SERVICE BULLETIN No.1191

COACH MODEL	: T2100 and C2000 Series
BULLETIN TYPE	: Product Improvement
SECTION	: Section 9 – Electrical system
DATE	: August 24, 2006
SUBJECT	: High mount stop lamp change
TERMS & CONDITIONS	: No claims will be accepted with reference to this Bulletin.

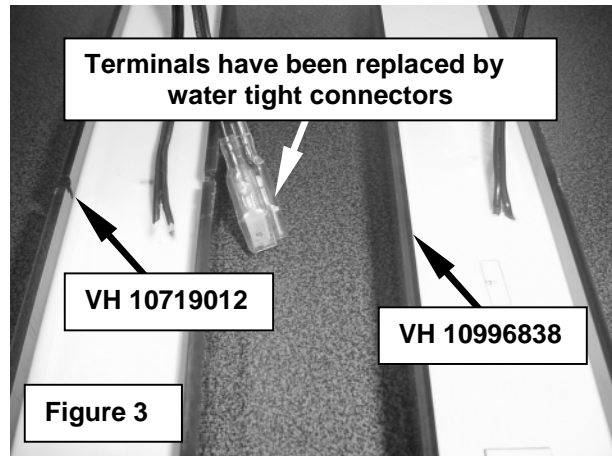
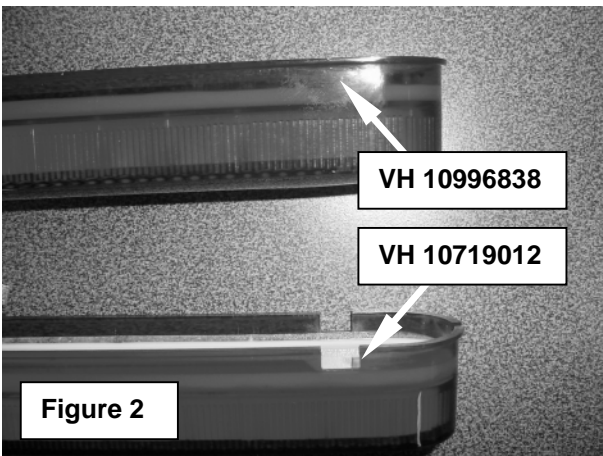
- It is directly interchangeable with the old one.
- The recesses in the housing have been deleted (see Figures 2 and 3). This eliminates cracking of the housing/lens and ingress of moisture. This also makes for a much stiffer assembly.
- The resin layer embedding the LED's and the reflector has been slightly increased for better sealing properties.

**Figure 4: Stop lamp VH 10996838 replaces stoplight VH 10719012
Bezel VH 10698202 can be reused**

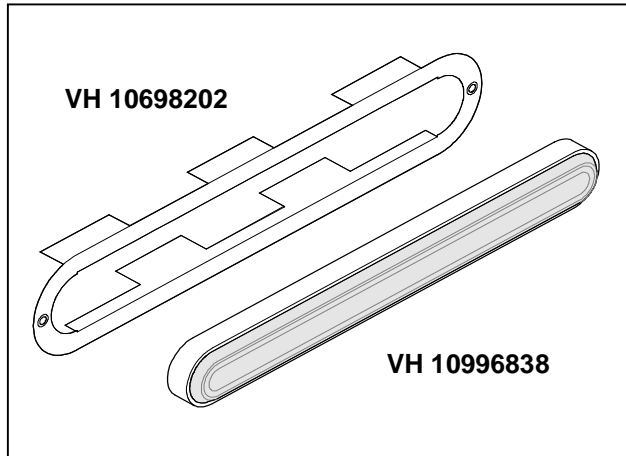
1. High mount stop lamp VH 10719012 has been revised by the supplier and an improved replacement part has been made available as part number VH 10996838.

Figure 5: Connector VH 10998909

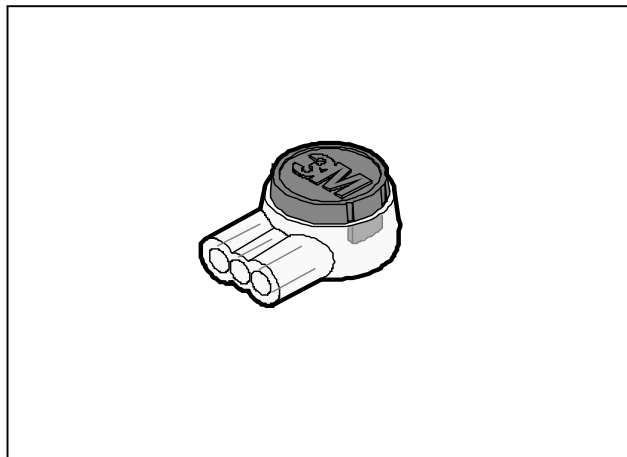
4. The terminals used to hook-up the lamp to the coach wiring have been replaced by butt connectors, which are gel filled and gas tight. Wires are simply inserted into the housing and crimped down, which actuates an insulation displacement mechanism automatically connecting the two wires into an environmentally gel sealed unit. To install, a suitable crimping tool is required (see Figure 8 further in the procedure).
